CITY OF GLENDALE, CA

DESIGN REVIEW STAFF REPORT – SINGLE FAMILY

2026 West Mountain Street

PADR-003696-2024

PROPOSED
SITE PLAN

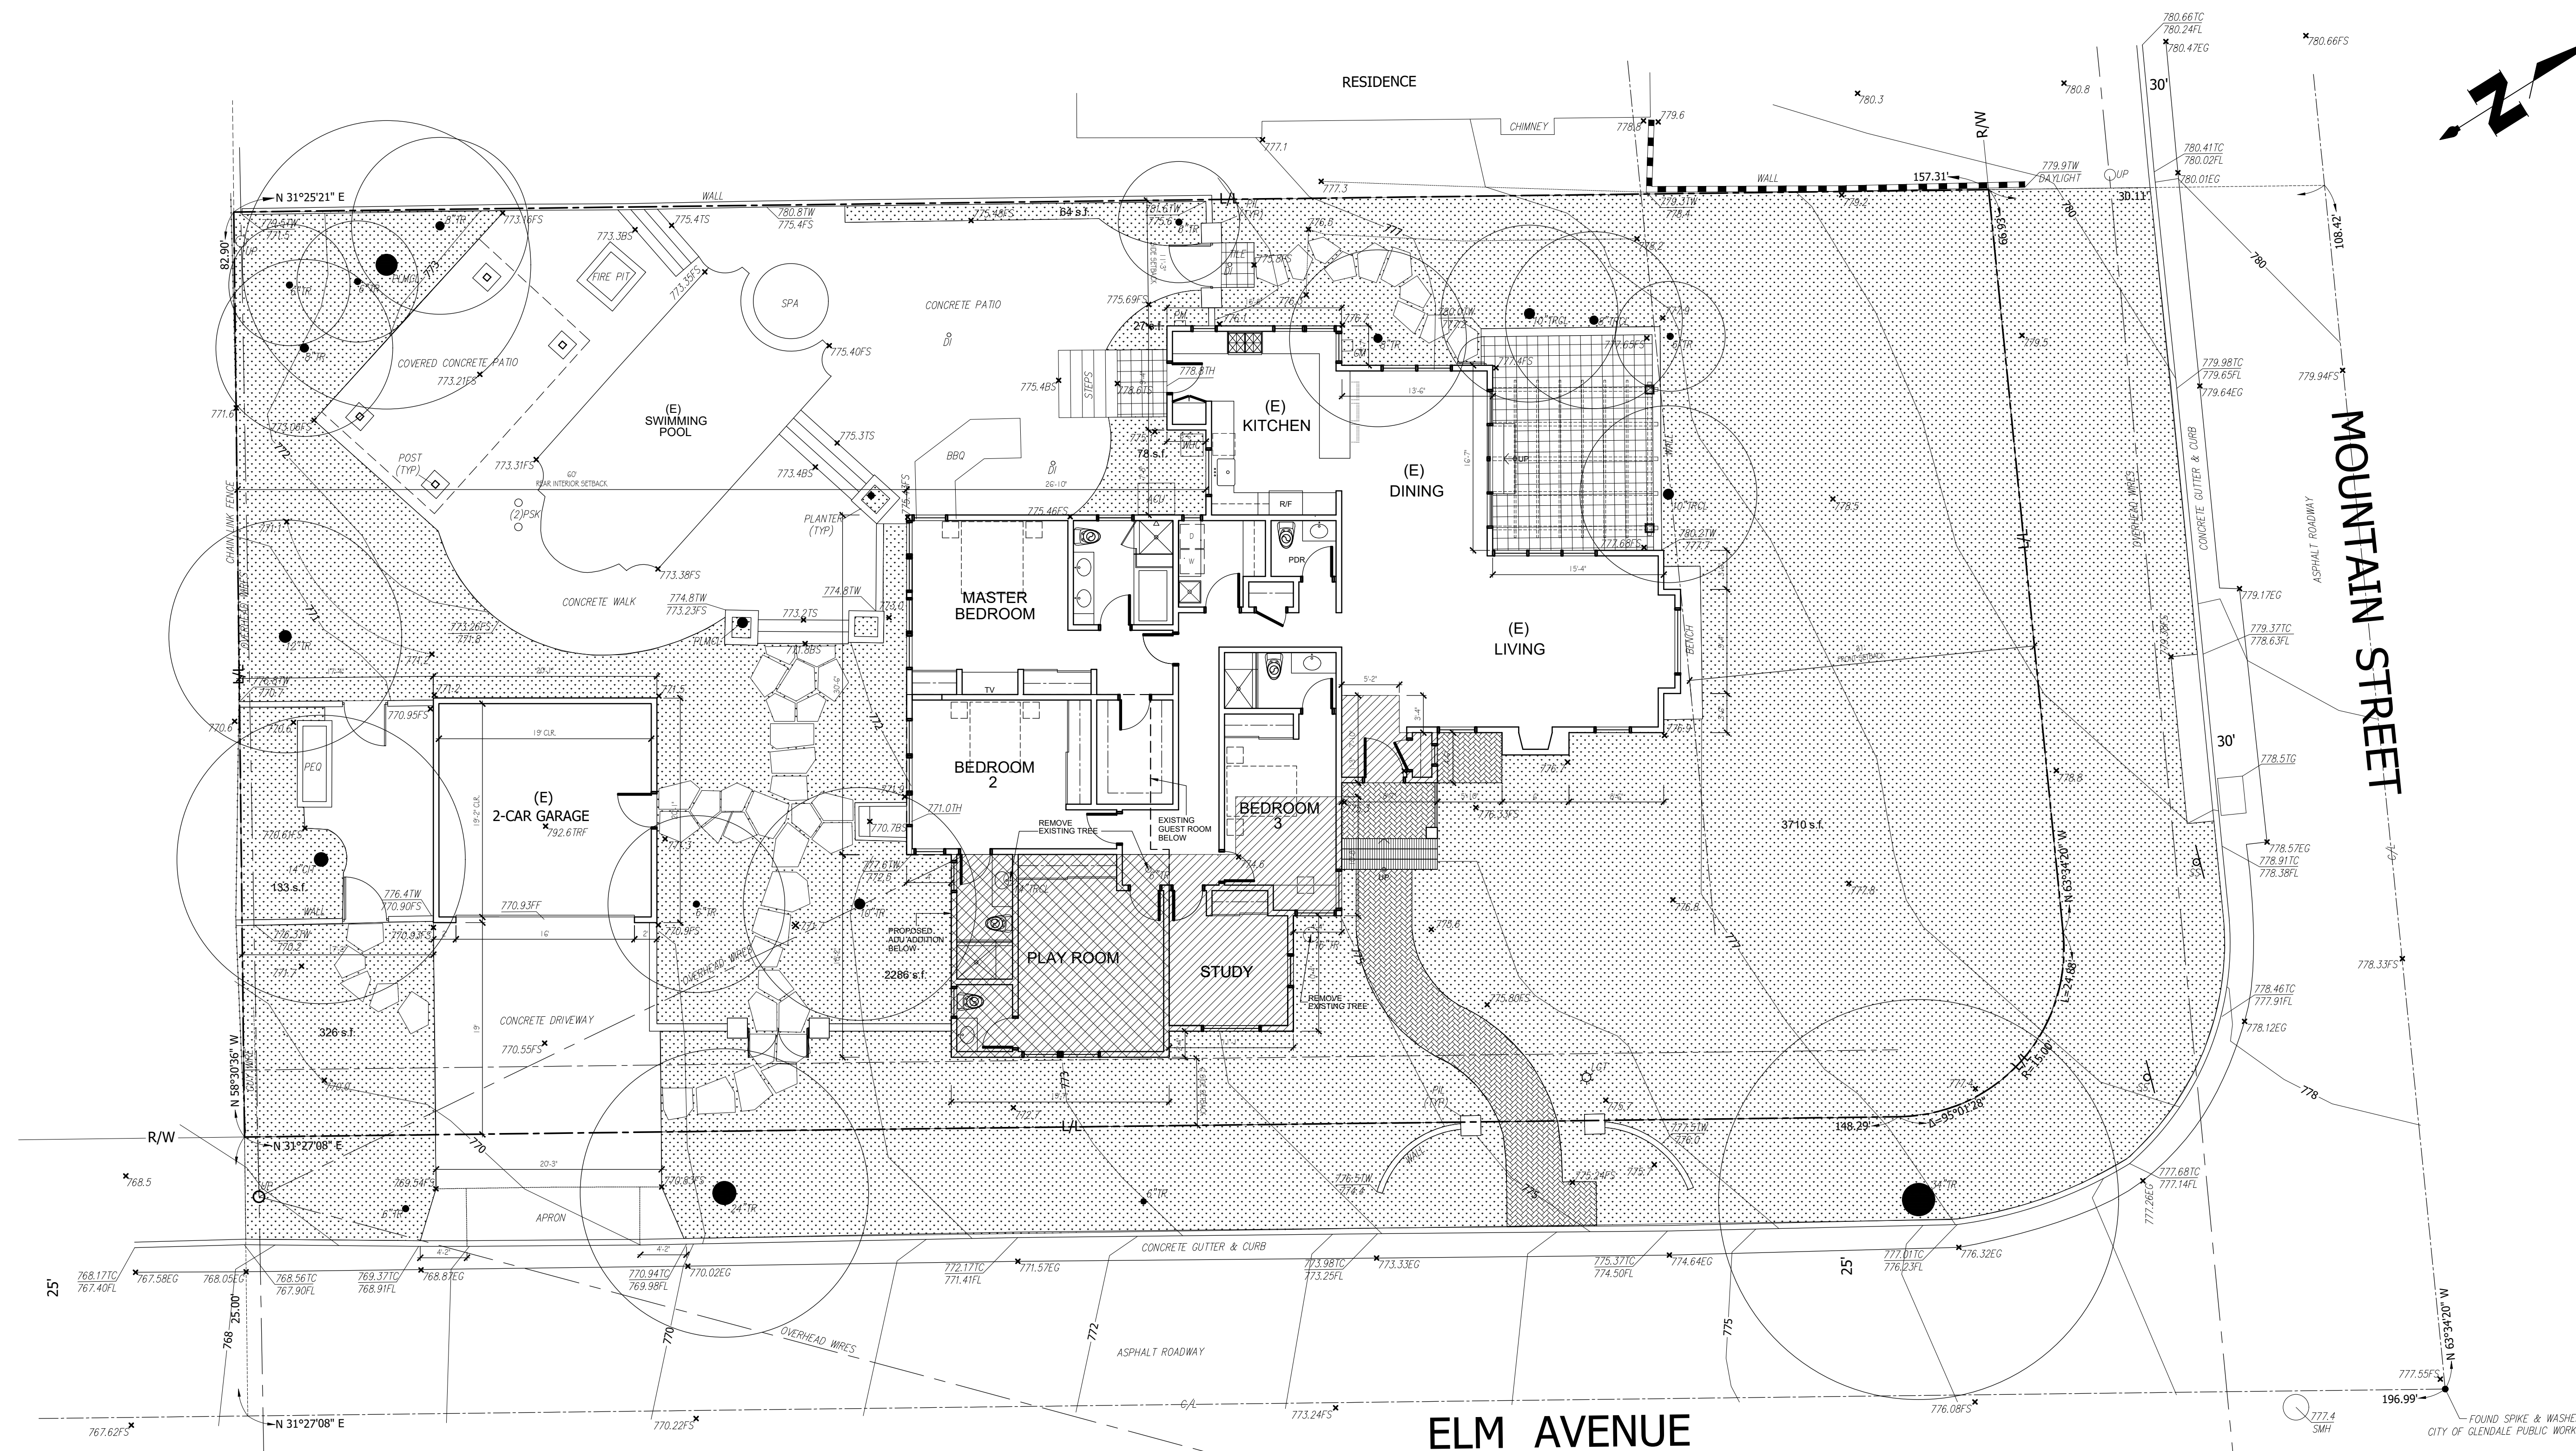
The existing side yard wall between the garage and the residence facing Elm Avenue is proposed to be replaced with the new wall that will extend out towards the street.

The new wall is shown on the plan with the same design and height as the existing. A condition is placed to revise the plan to include the height dimension of the walls to verify that it is below 7 feet in height.

1. Revise plans to include a window schedule and verify block frame installation for replacement windows and recessed nail-in framing for new construction windows.
 2. Preserve the existing leaded glass window.
 3. Provide an image material board with specifications of materials.
 4. Revise plans to color the proposed elevation drawings.
 5. Provide landscape plan in compliance with GMC Chapter 30.31.
 6. Revise plans to dimension the height of the new walls.
-

PROPOSED BUILDING
EAST AND NORTH ELEVATIONS

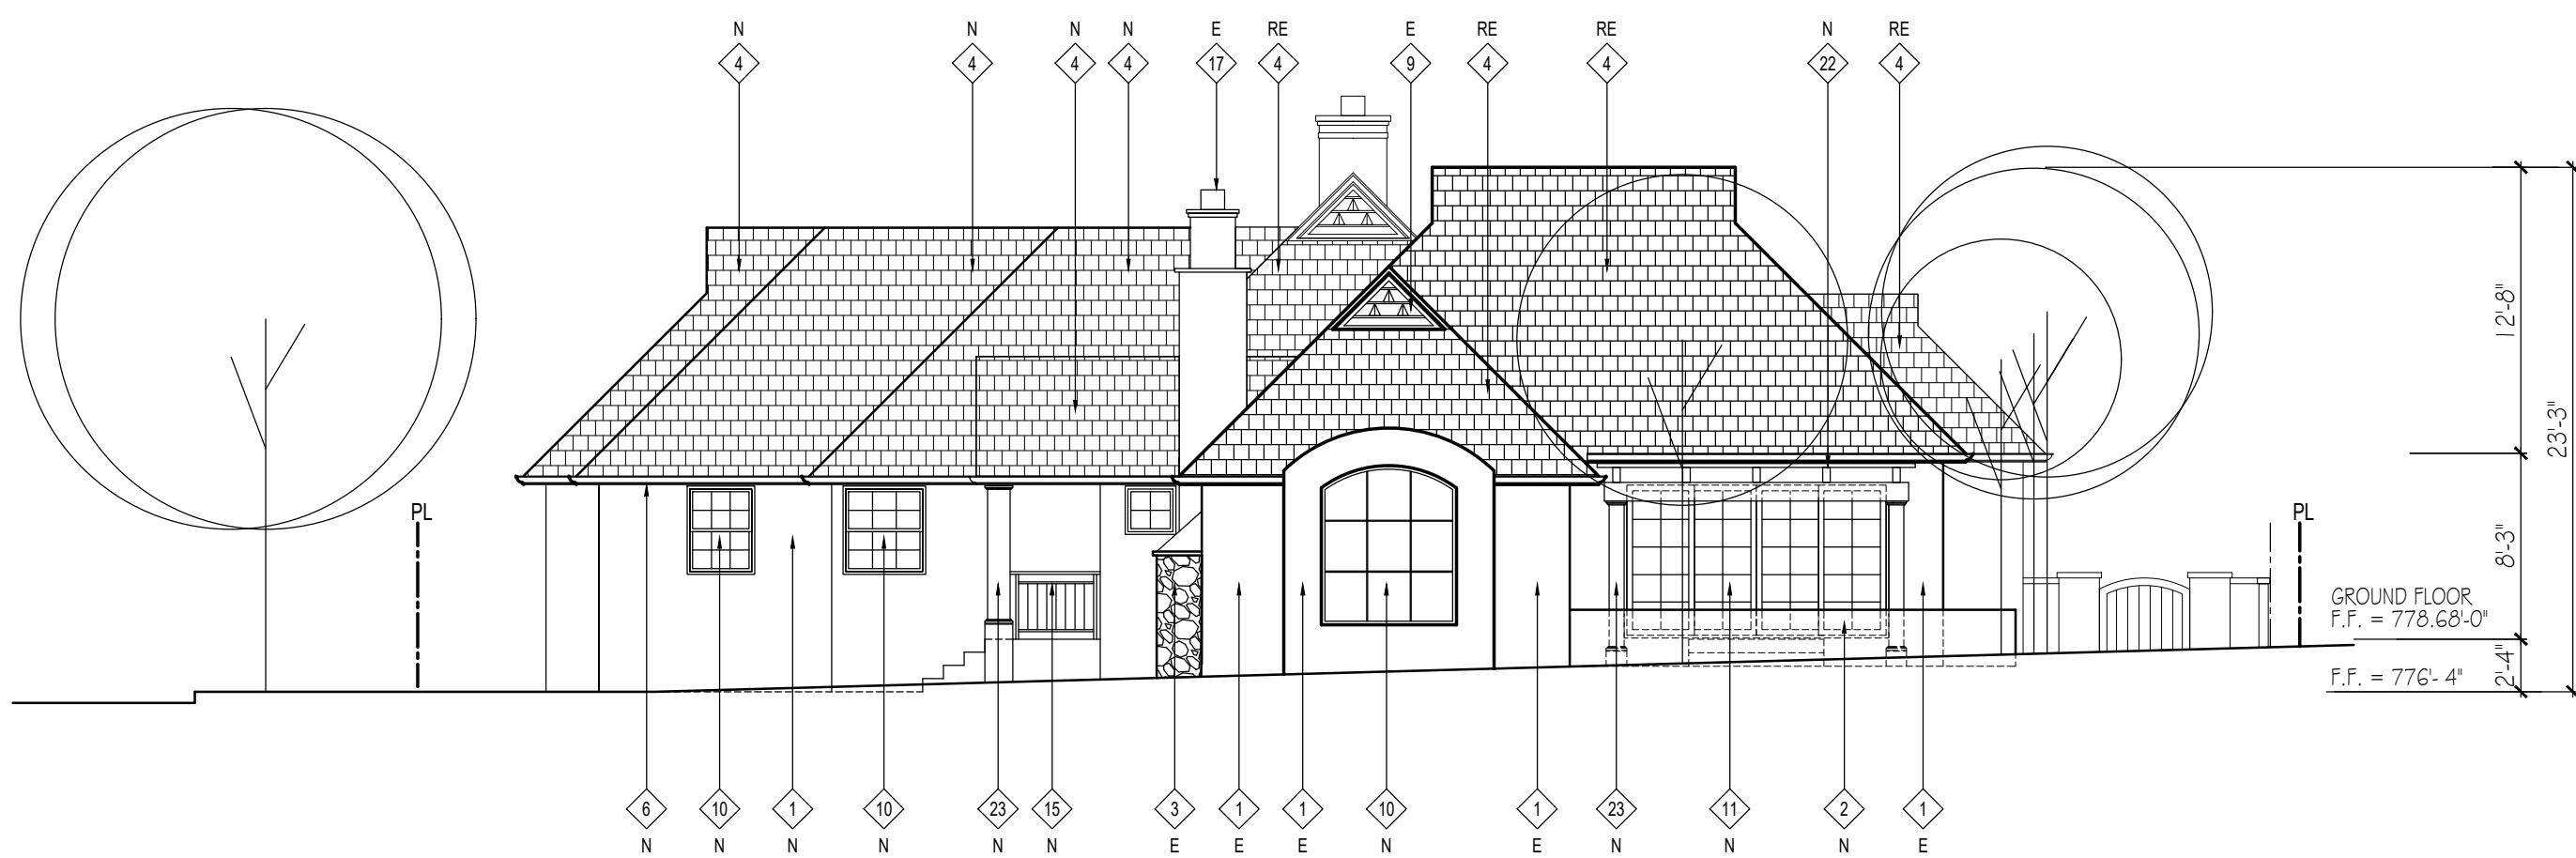
The proposed plan calls out a metal light fixture that is not shown on the material board and does not include any specifications. A condition is placed to show the proposed sconce on the material board.
